**The Woodlands Off-Site Sanitary Lift Station, Force Main & Gravity Sewer Line A (RFCSP)**

**Solicitation Number: CO-00682**

**ADDENDUM 3**

**November 15, 2023**

SHEET NO.  
**E-20**

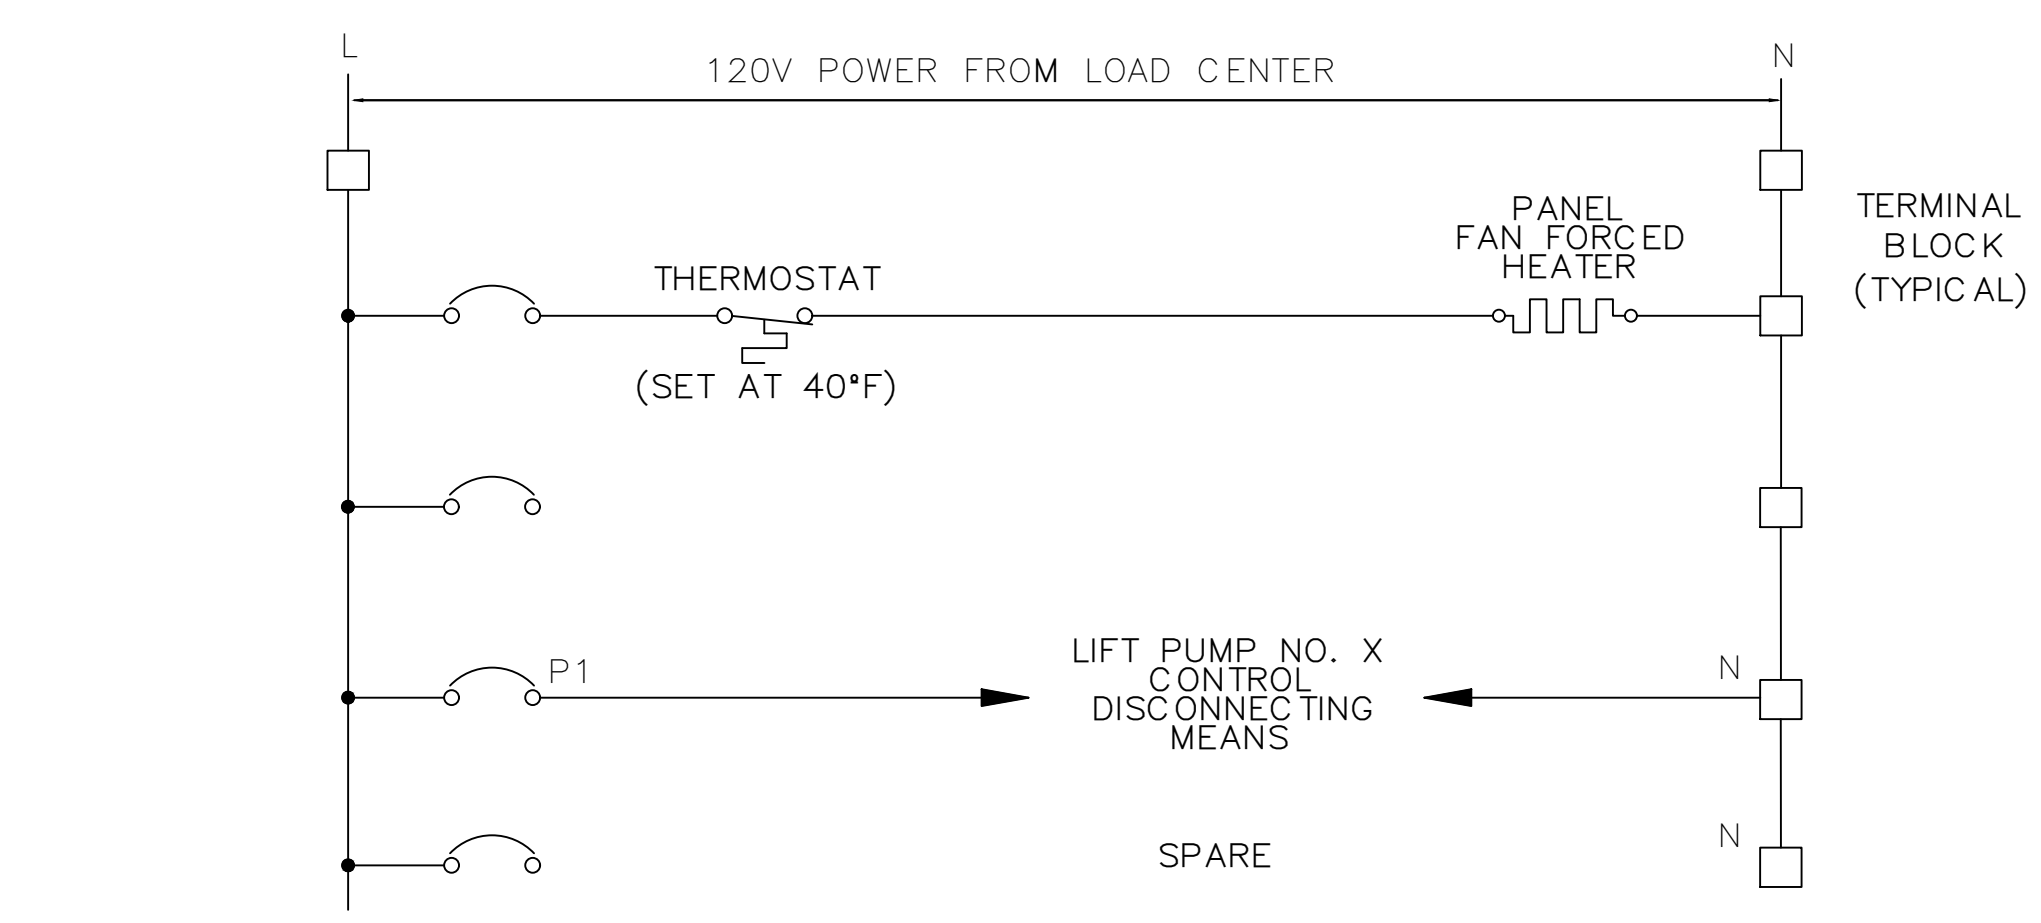
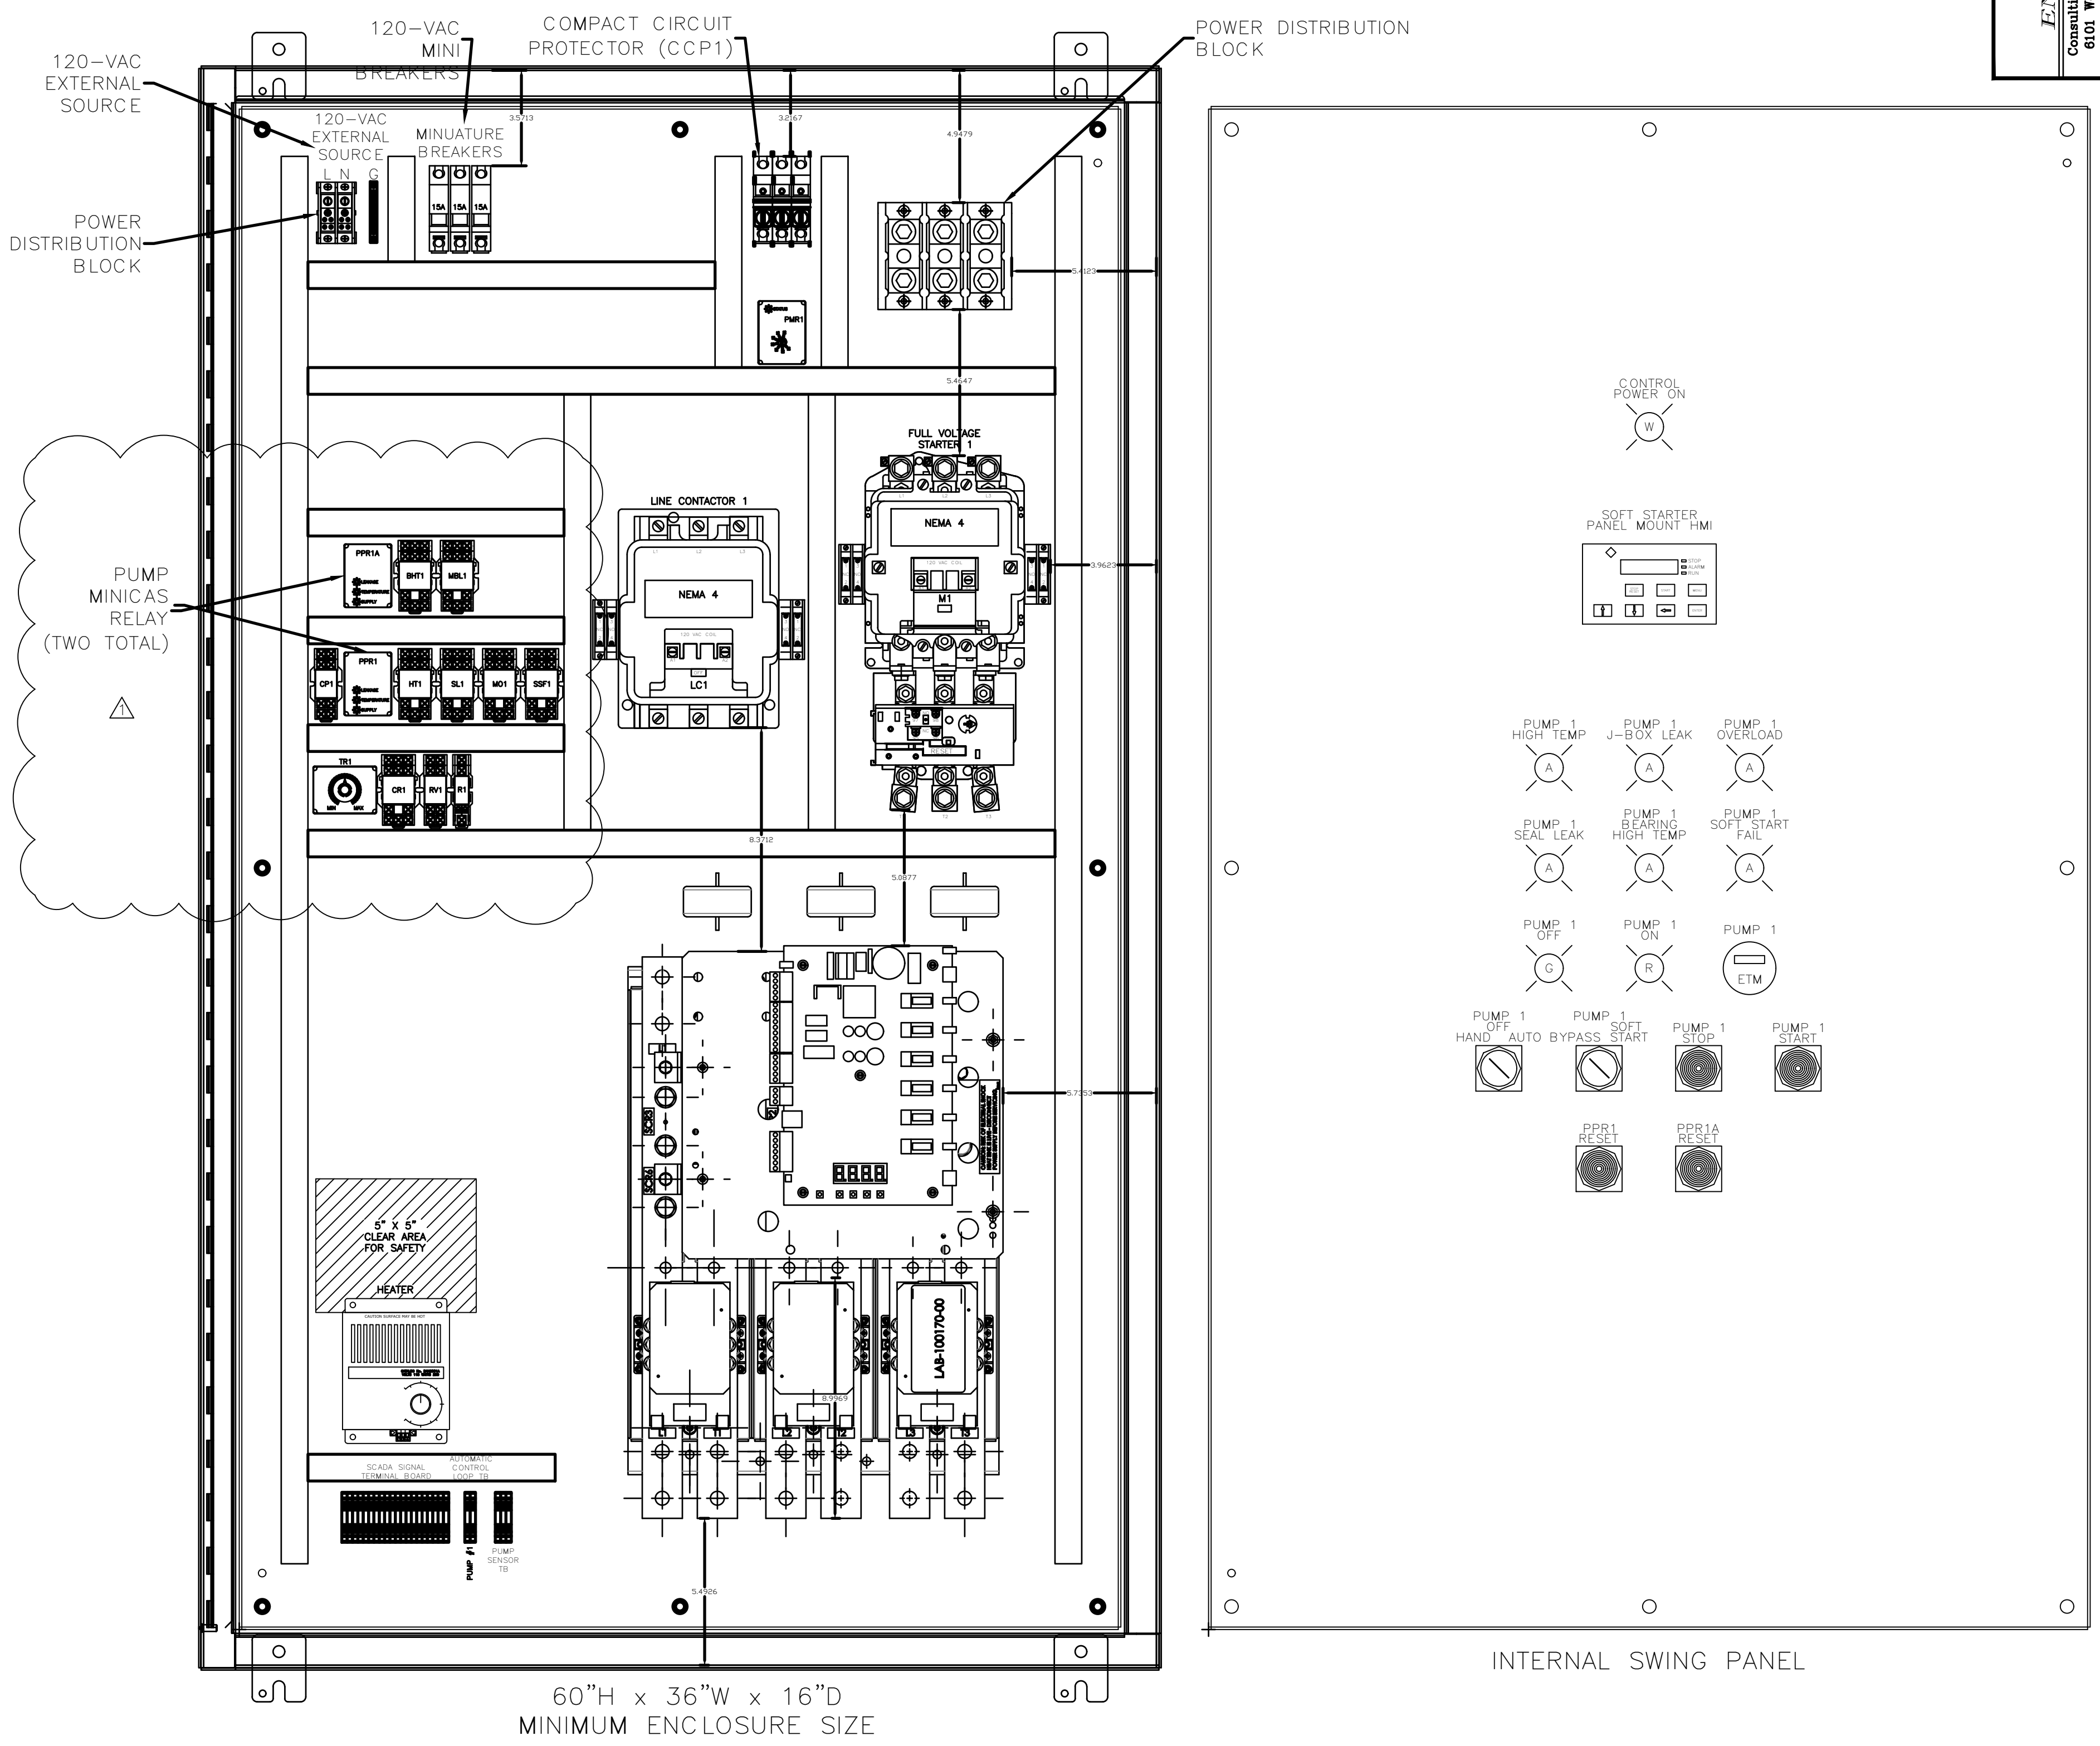
34. **Question:** There is a conflict in the drawings and the spec for the pump sensor relays. Flygt does not make a pump sensor relay to monitor the thermals, the leak and the bearing temperature. To accomplish this, a separate sensor cable has to be run. The specs call for the MAS 801 to be used which is a two wire system to monitor multiple pump sensors. This uses the set of control wires from the power cable to accomplish this.

**Answer:** *There will be two Minicas pump sensors installed per pump. See Changes to the Plans #1. Sheets E-10, E-11, and E-20 have been revised accordingly.*
